Woodstock Quarries Ltd

Woodstock Quarry RFI - response to geological questions

Woodstock Quarry – Revised Pit Slope Design

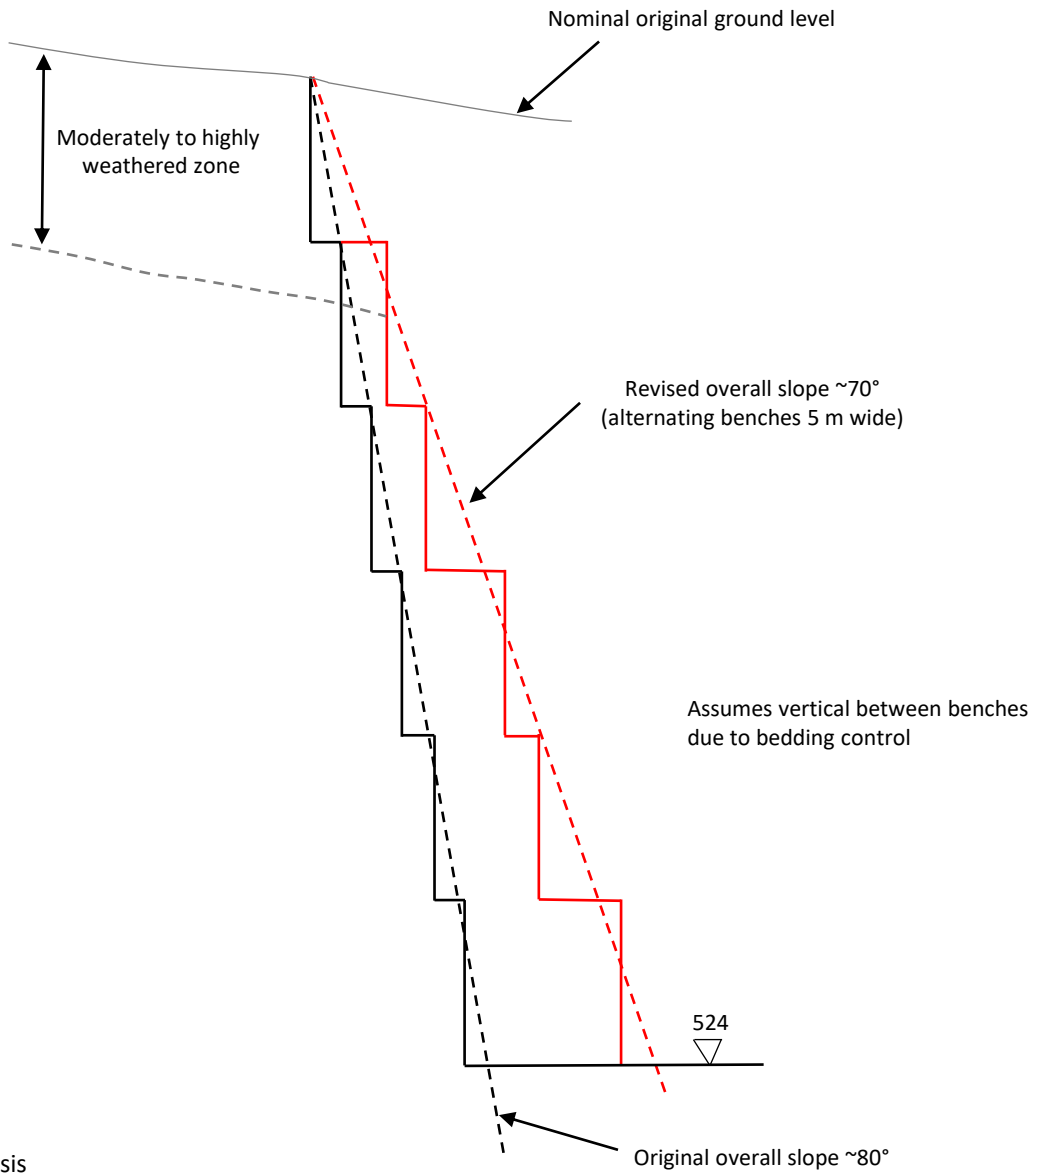
- b. In Section 5.5 of the Geology Report the first paragraph states that the quarry walls will be cut at an unstated angle (presumably dictated by rock defect dip in each wall) with 10 m high inter-bench heights and a 2 m bench. Firstly, this gives an overall angle of 79 degrees which is steeper than the Joint sets J1 and J3 in Table 1 of the Geology report and those shown in Figure 6. Depending on wall vs Joint orientation rock blocks underlain by J1 and J3 will daylight in the proposed cut face and are likely to be unstable as indicated in Appendix C. This could lead to local cut slope failure and represent a danger of rockfall to site staff. Has this risk been considered in the selection of bench width design?

- c. The cross-sections in Drawing B4 illustrate the proposed cut wall slopes. The scale is uncertain but one of the cut walls may be 80 m high if the height intervals are 10 m. This highlights the potential safety issue and the need to ensure the rockfall risk is adequately

managed for staff safety. One example from open cast NZ coal mines, is the use of a highwall profile with a 15 m inter-bench height and 8 m bench width to manage rockfall and to provide maintenance access. This gives an overall wall angle of 62 degrees. This angle may better manage both wedge and toppling failure types at Woodstock.

Q23 Overall, considering the above points, the applicant should either reconsider or further justify the proposed cut slope profile, particularly with respect to the design cut slope angles and 2 m inter-bench width to ensure consistency with the geological defect orientations, the adequacy of the proposed bench width and its ability to control rockfall from a safety perspective.

Response: Based on the above helpful comments and suggestions, the slope design has been reconfigured to improve safety. The revised proposed design is provided as an attachment. The design philosophy, as noted on the drawing, is

- 10m vertical separation between benches
- Bench widths of 2m and 5m (alternating)
- 5m wide bench within weathered zone (exact base of weathering unknown and expected to vary)
- Overall slope angle ~70°

Response: The proposed bench widths, batter slope angles and height between benches are conservative and are designed based on kinematic analysis (presented in the report – p16-17 and Appendix C). Following initial review comments by T+T, the bench widths were increased to 5m, thus reducing the overall slope angle, as detailed above, to improve overall stability and reduce the risk of rockfall to workers.

1. 10 m vertical between benches
2. Bench width 2 m and 5 m alternating
3. Overall slope ~70°
